Item Name: Mirror Arm Upgrade

DART SERVICE INSTRUCTION

TO AMEND INSTALLATION INSTRUCTIONS IIN-D119-696 REV. A AND INSTRUCTIONS FOR CONTINUED AIRWORTHINESS ICA-D119-696 REV. 0

A	NEW ISSUE	MB	11.10.04
REV.		BY	DATE
DESIGN		DART AEROSPACE USA, INC	
DRAWN		KENT, WA	
CHECKED		DRAWING NO.	REV. A
MFG. APPR.		DSI 9578	SHEET 1 OF 3
APPROVED		TITLE	SCALE
DE APPR.		MIRROR ARM UPGRADE	NTS
DATE	11.10.04	COPYRIGHT © 2011 BY DART AEROSPACE USA, INC THIS DOCUMENT IS PRIVATE AND CONFIDENTIAL AND IS SUPPLIED ON THE EXPRESS CONDITION THAT IT IS NOT TO BE USED FOR ANY PURPOSE OR COPIED OR COMMUNICATED TO ANY OTHER PERSON WITHOUT WRITTEN PERMISSION FROM DART AEROSPACE USA, INC.

FIGURE 1

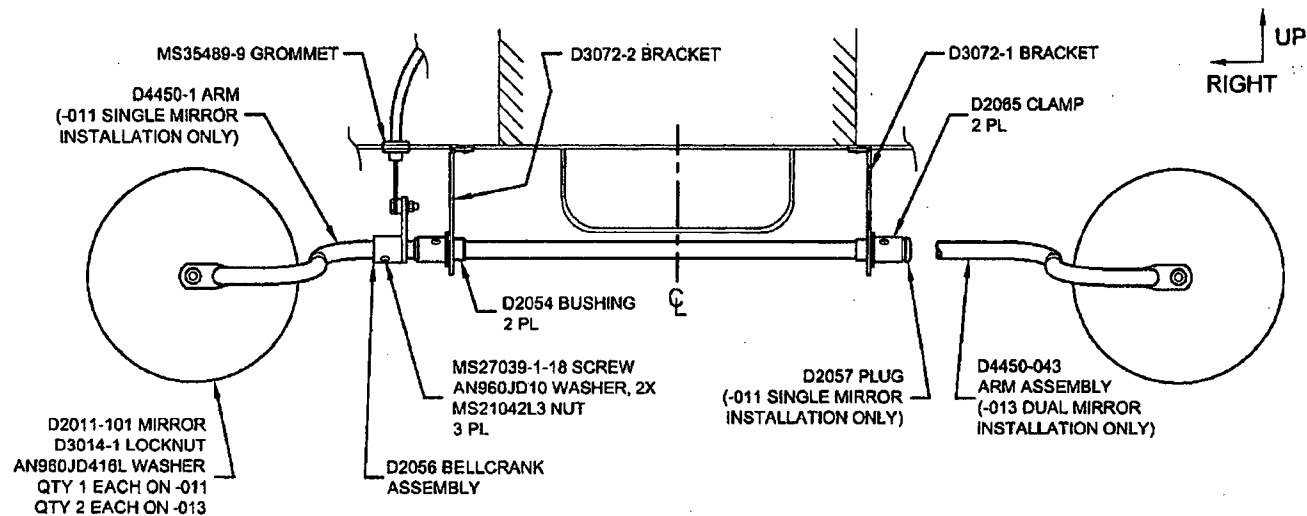
This service instruction details the D119-696-011/-013 Cargo Mirror Installations at CHG 006 which have been improved with D4450-1/-043 Arm/Arm Assembly. The D4450-1/-043 replaces D3074-1/-3 and feature a more robust and ergonomic design. Customers/operators who wish to upgrade existing D119-696-011/-013 Cargo Mirror Installations at earlier change numbers may procure the DSI-9578-011/-013 Kit from Dart. The revised weight and balance and parts list on page 2 of this service instruction are to be used for D119-696-011/-013 Cargo Mirror Installations at CHG 006.

1. Remove and discard existing D3074-1 Arm and existing D2057 Plug.
2. Install D4450-1 Arm and replacement D2057 Plug in accordance with Figure 1 of this service instruction.
3. Install D2011-101 Mirror to D4450-1 Arm using D3014-1 Locknut as shown in Figure 1 of this service instruction.

1. Remove and discard the existing D3074-3 Arm and associated parts/hardware. Note that the D3074-3 Arm also includes 2 X D2052 Brackets, 2 X D2055 Clamps, a D2056 Bellcrank, 2 X D2054 Bushings, and attaching hardware.
2. Install D4450-043 Arm Assembly in accordance with Figure 1 of this service instruction.
3. Install 2 X D2011-101 Mirrors to D4450-043 Arm Assembly using D3014-1 Locknuts as shown in Figure 1 of this service instruction.
